SUBJECT: RFP NO. 071940 BANANA YARD RAIL SWITCH UPGRADE

ADDENDUM NUMBER # 02

REVISED DRAWINGS FOR BANANA YARD RAIL TURNOUT REPLACEMENT

2 RAIL SECTION 136#
C5 SCALE: 1" = 1'

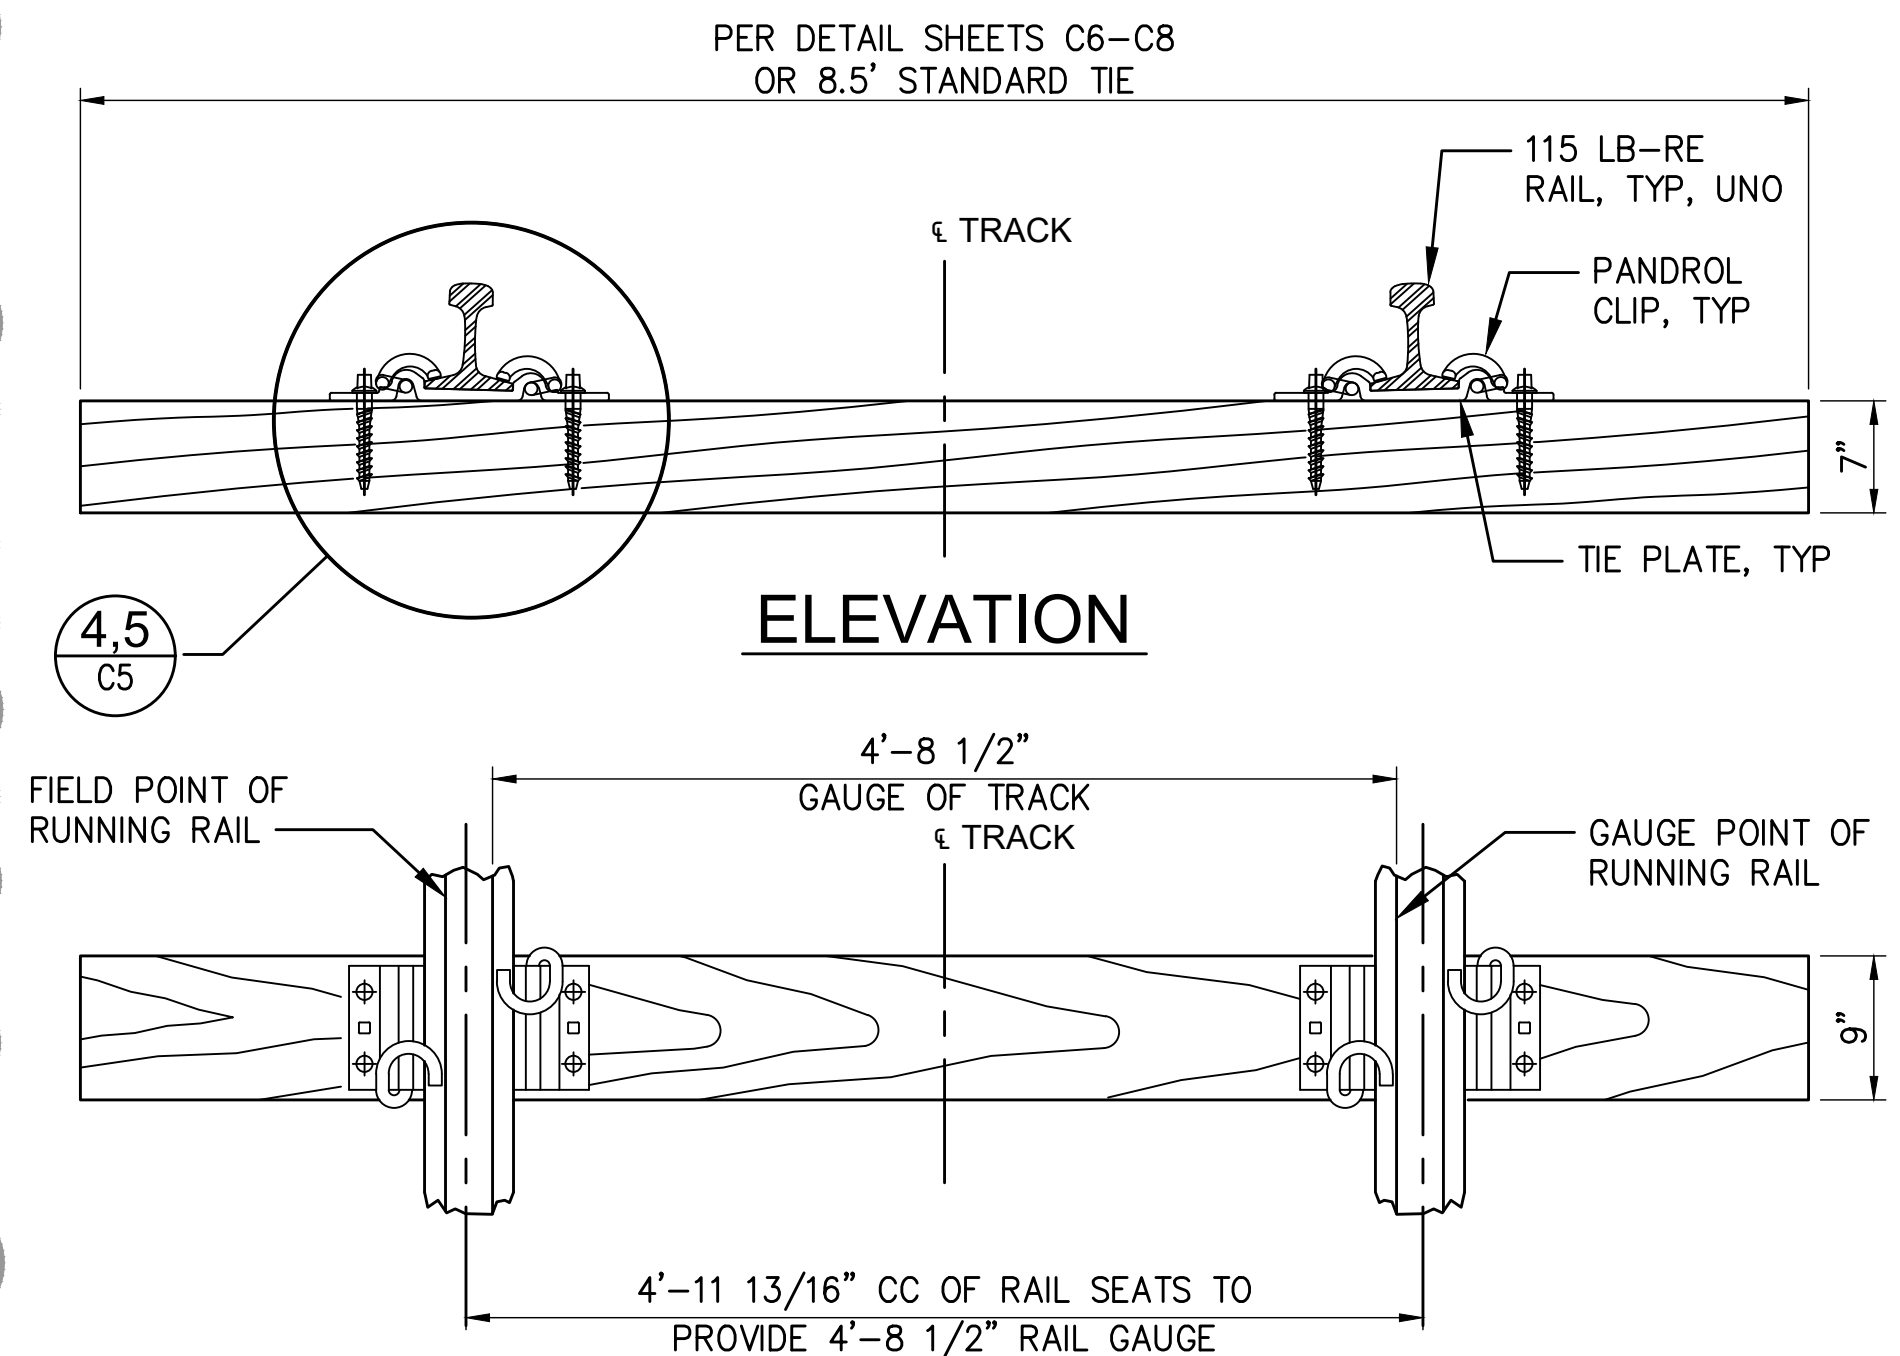
DETAIL 2 HAS BEEN REMOVED. 136#
RAIL NOT INCLUDED IN PROJECT.

5 TIMBER TIE FASTENERS W/136# RAIL
C4, C5 SCALE: 1 1/2" = 1'

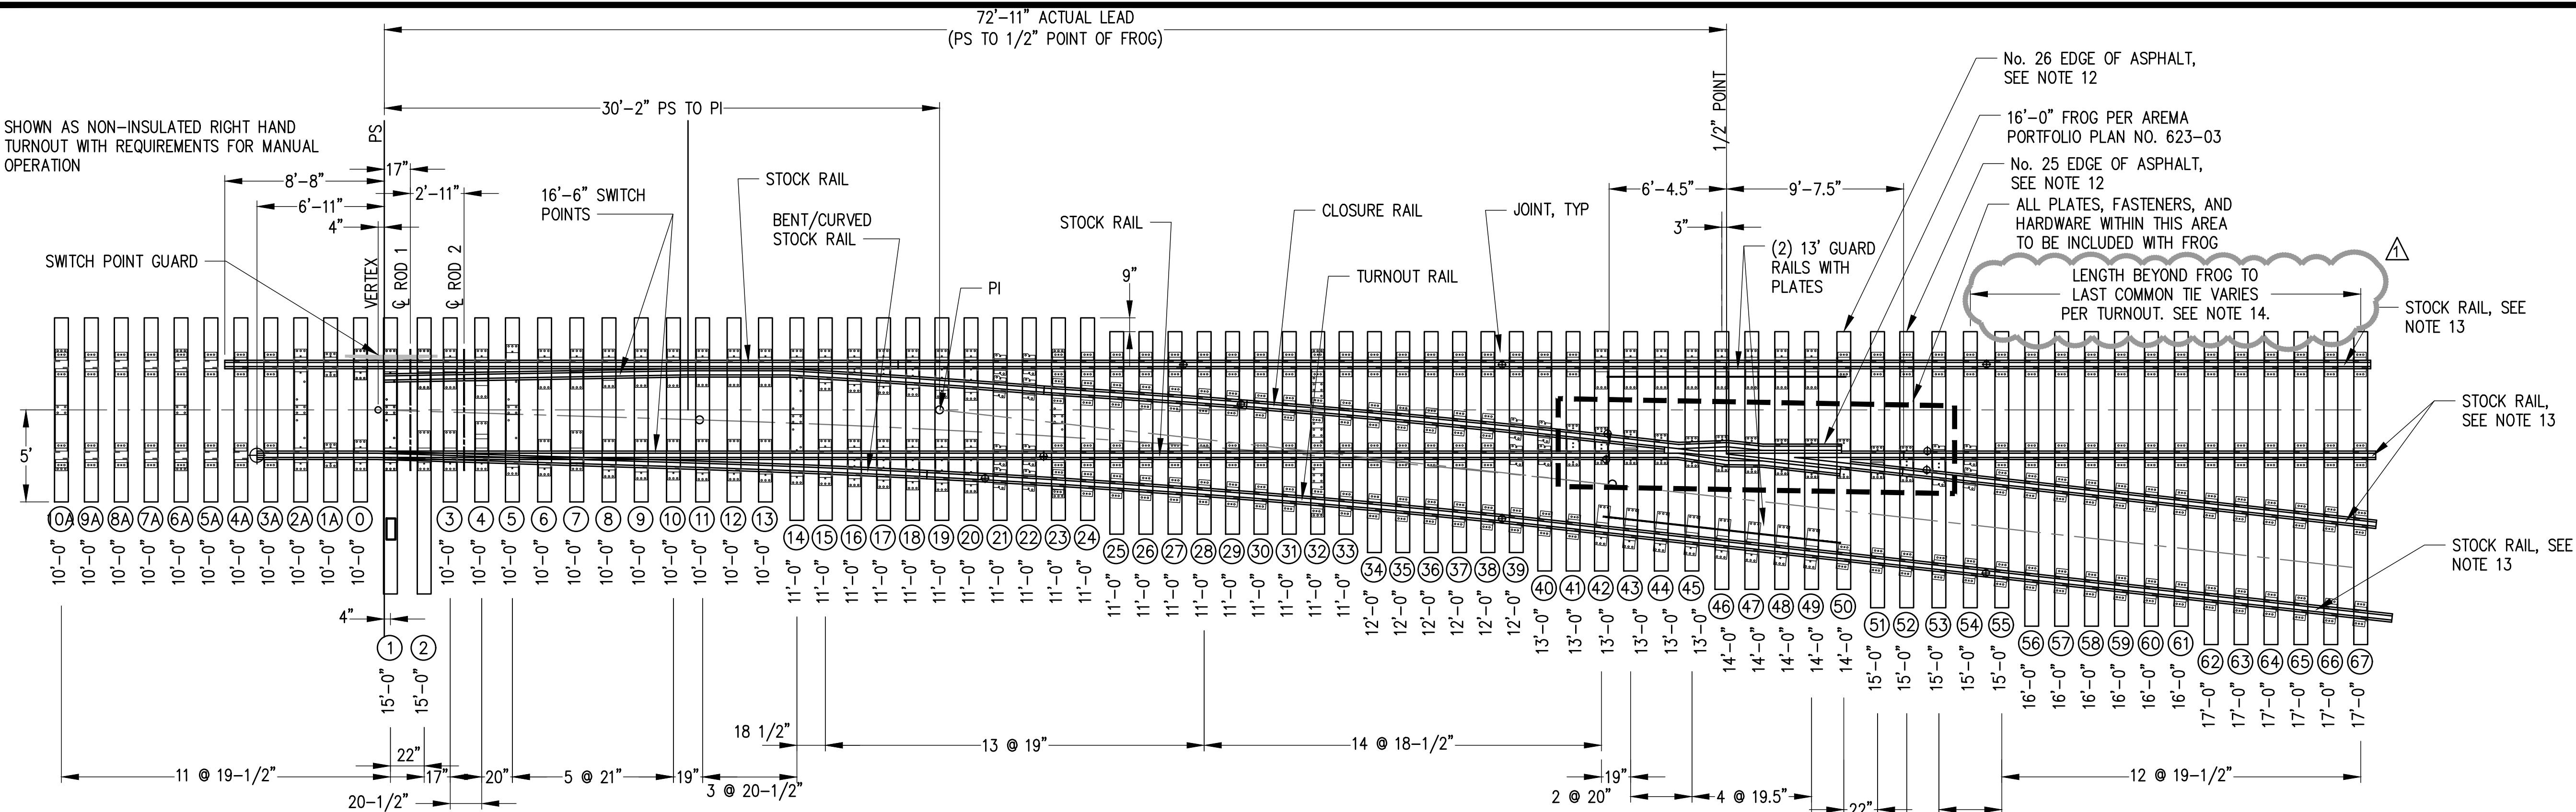
DETAIL 5 HAS BEEN REMOVED. 136# RAIL
FASTENERS NOT INCLUDED IN PROJECT.
